Power Genius XL™ Release Notes – Version 3.8.4

September 6, 2023 (revised September 28, 2023)

Power Genius XL version 3.8.4 is a maintenance release for use with all Power Genius XL (PGXL™) amplifiers.

More Complete Error/Status Messages Sent to FLEX-6000 Radios

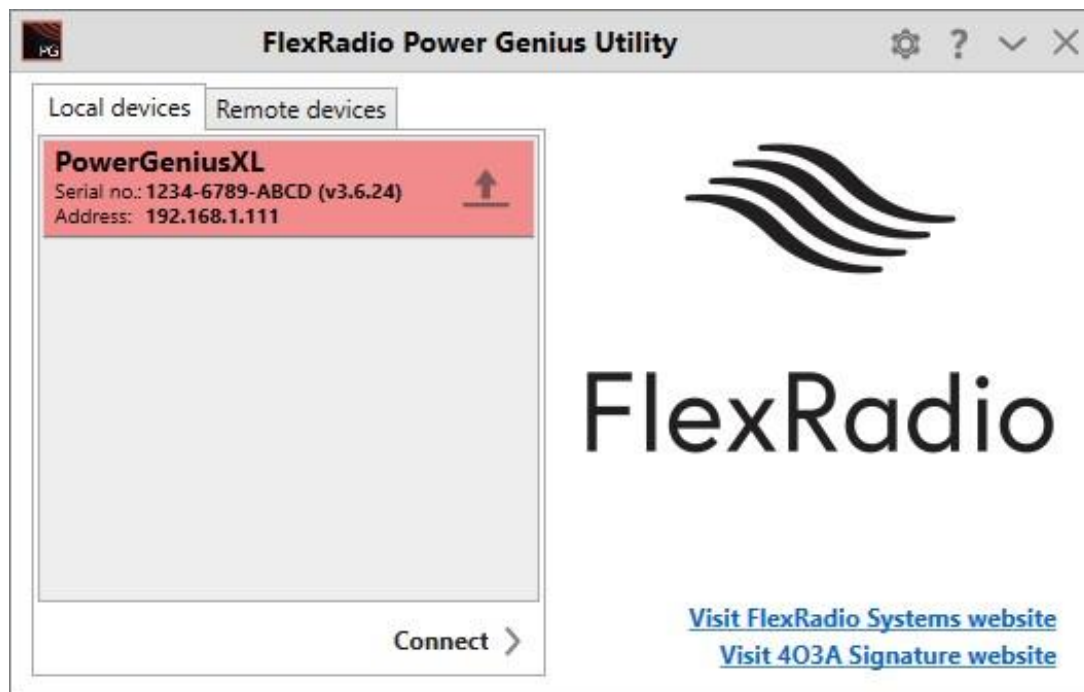
This version of the firmware sends more complete status and error messages to Flex radio exciters than previous versions. These messages should help in understanding configuration and error conditions when they arise.
